**ITEM** 1-13 Close Street and 242-258 Canterbury Road,  
Canterbury

**Reconfiguration of built form, adjusted and improved public domain works, a revised unit mix, and internal layout changes. Increased height (additional 2-storeys/6m) and GFA (additional 2368sqm).**

<b>SSPP Ref No.</b>	<b>PPSSSH-106</b>
<b>FILE</b>	<b>DA-503/2013/B</b>
<b>ZONING</b>	<b>Part B2 – Local Centre and Part R4 – High Density Residential</b>
<b>DATE OF LODGEMENT</b>	<b>21 December 2021</b>
<b>APPLICANT</b>	<b>Realize Architecture Pty Ltd</b>
<b>OWNERS</b>	<b>Metro Storage Pty Ltd</b>
<b>ESTIMATED VALUE</b>	<b>\$114 337 456</b>
<b>AUTHOR</b>	<b>ABC Planning P/L</b>

### **SUMMARY REPORT**

**Image 1: Section excerpt showing the proposed height will be 3-storeys greater than the 27m height limit shown dotted in blue, noting that the approved development was already 1-storey greater than the height limit**

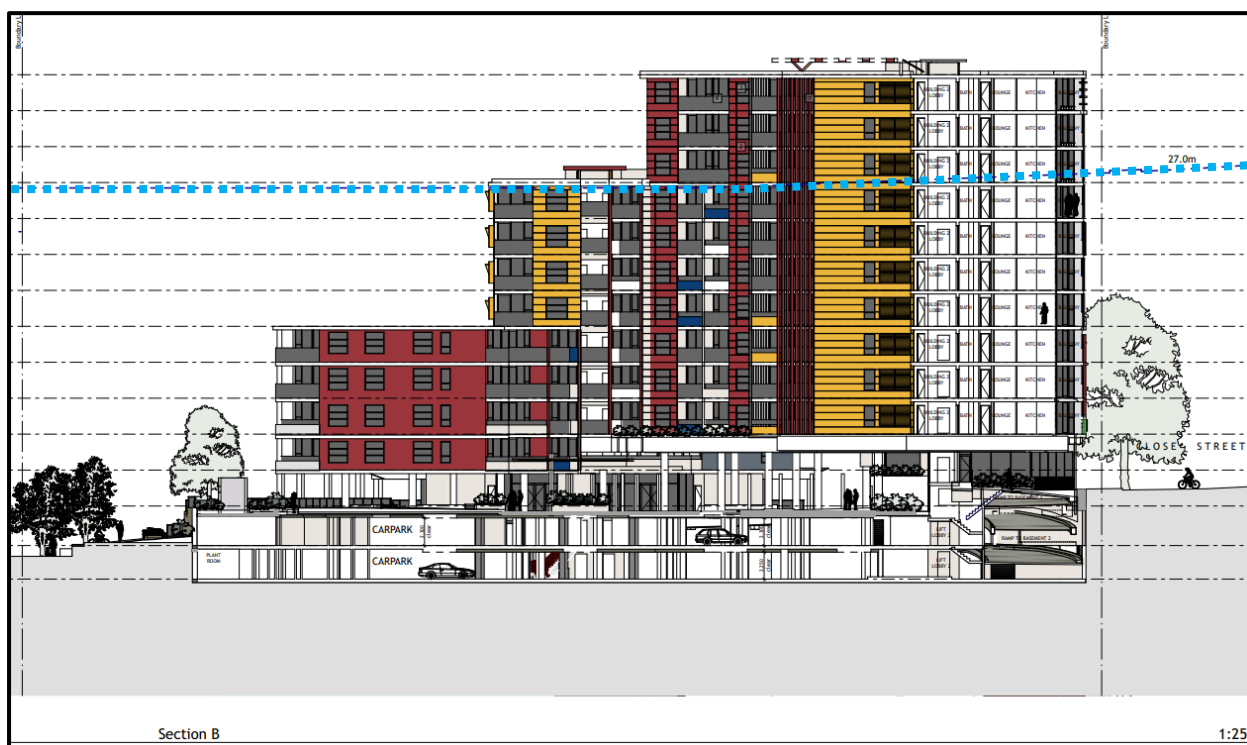
The LEP height standards and accompanying DCP storey requirements envisage heights of 6-9 storeys on this site. The proposed development now seeks a height of 11-storeys which is considered to be inconsistent with the desired future character. The greatest height limit on the site is mapped to have an overall height of 27m. The approved height already breaches the 27m height limit. A proposed maximum height of 36.85m is now sought, which increases the height variation from 3.85m to 9.85m.
